## NOTICE OF ADDENDUM NO. 1

State of Rhode Island  
Solicitation Number 7553498  
CBLS Cooling Tower Improvements  
University of Rhode Island  
Kingston, Rhode Island

**DATE OF ADDENDUM:**                    **June 9, 2017**

# APPENDIX A

SKA-2

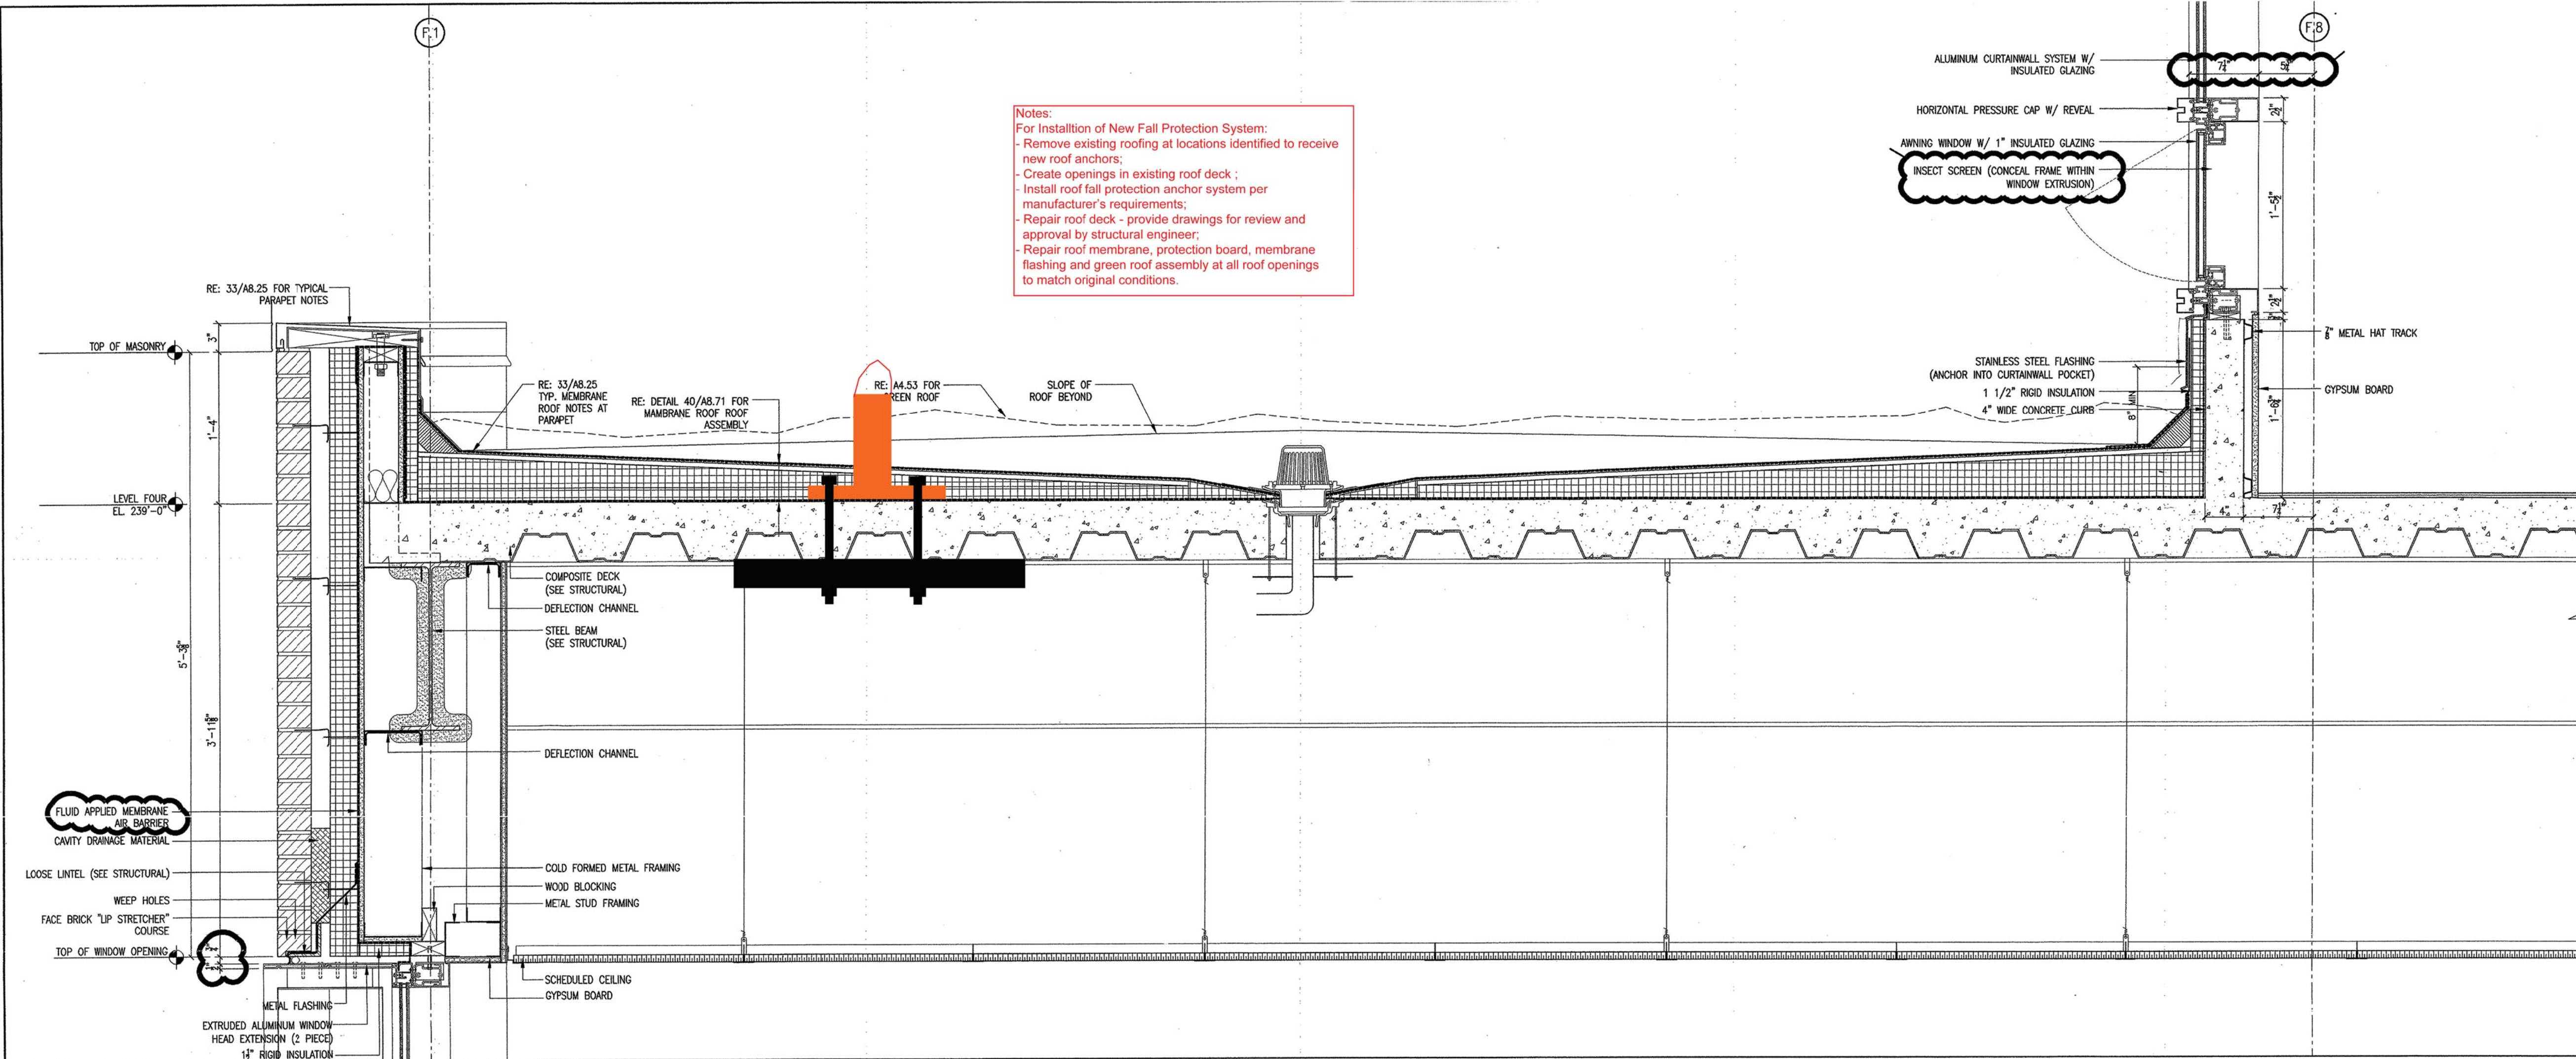
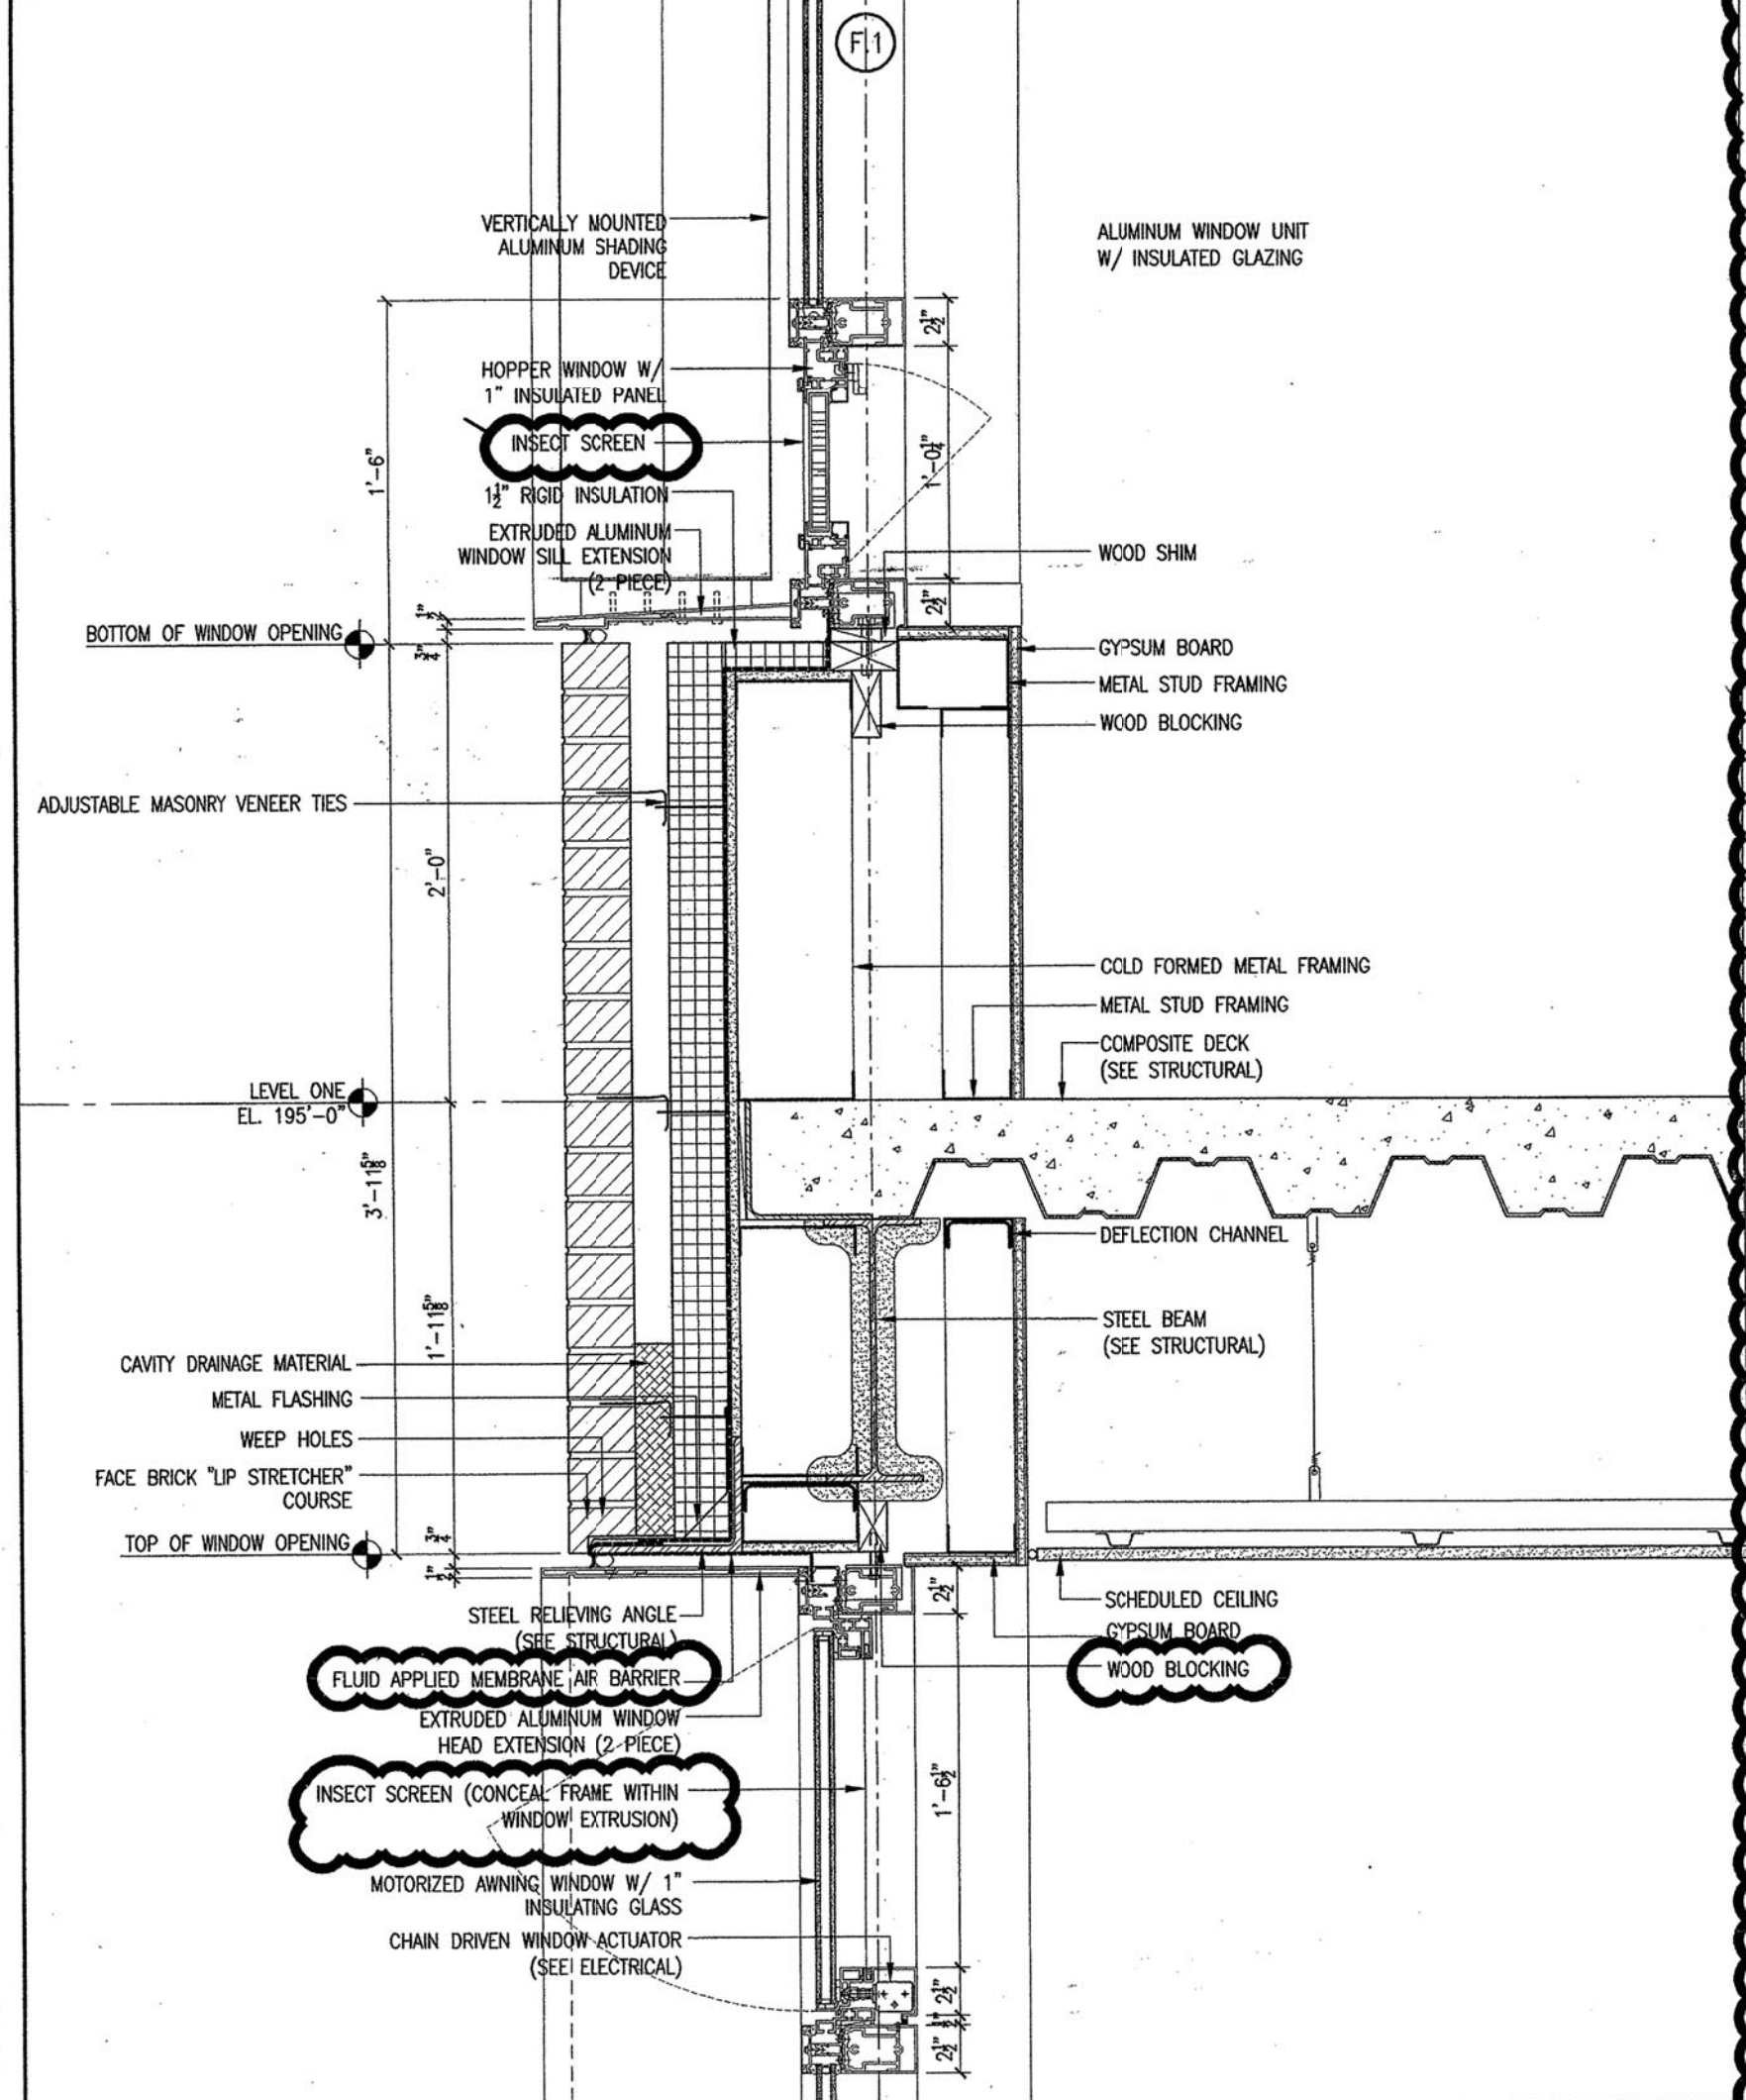
**Notes:**  
 For Installation of New Fall Protection System:  
 - Remove existing roofing at locations identified to receive new roof anchors;  
 - Create openings in existing roof deck;  
 - Install roof fall protection anchor system per manufacturer's requirements;  
 - Repair roof deck - provide drawings for review and approval by structural engineer;  
 - Repair roof membrane, protection board, membrane flashing and green roof assembly at all roof openings to match original conditions.
